SUBJECT: SUMMARY OF AUGUST 23, 1990 MEETING BETWEEN
NRC, BONDICO, AND SAIC

The subject meeting summary is enclosed. This summary highlights the NRC/SAIC concerns regarding the structural stability of the fiberglass-reinforced plastic material used on Bondico's proposed HIC-7 high integrity container for disposal of low-level radioactive waste (Docket Number WM-94).

PURPOSE: TO DISCUSS NRC'S REVIEW OF THE STRUCTURAL STABILITY OF
BONDICO'S HIC-7 FIBERGLASS-REINFORCED PLASTIC HIGH-INTEGRITY
CONTAINER (DOCKET NUMBER WM-94)

Fig. 6. Plots of tensile yield strength vs. time (○) 98°C, (□) 85°C, (△) 70°C, (◇) 55°C

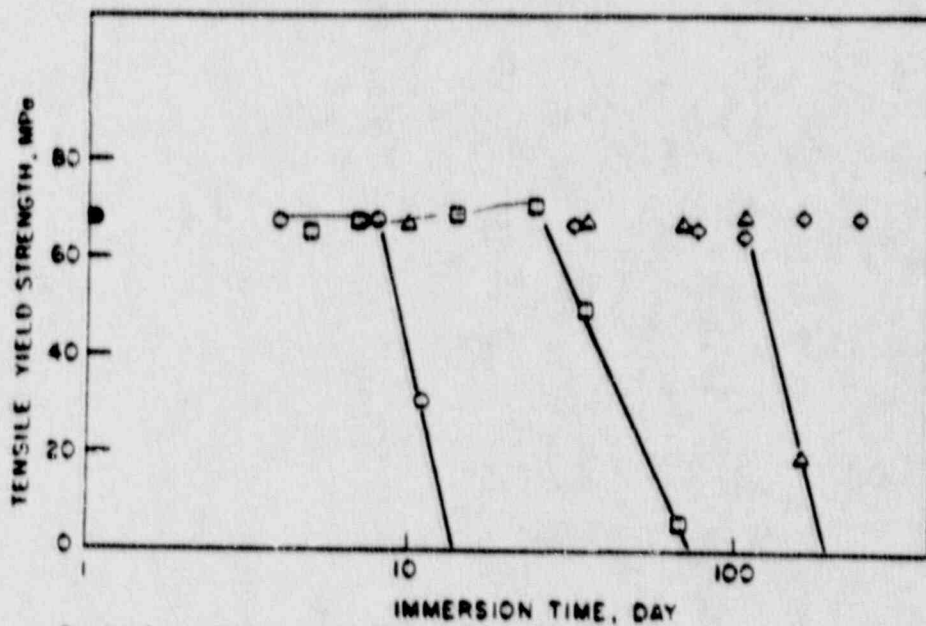
- Tensile yield strength remained constant then made rapid transition to failure (yield strain and strain to break coincided)
- Limited extent of reaction, one scission per chain, rate limiting step is hydrolysis, concentration dependence could be represented as zero order with respect to polymer average molecular weight
- The logarithm of rate constant showed a linear dependence on reciprocal temperature (i.e., followed Arrhenius relation)
- Projected service life of polyarylate at 15⁰C is 76 years
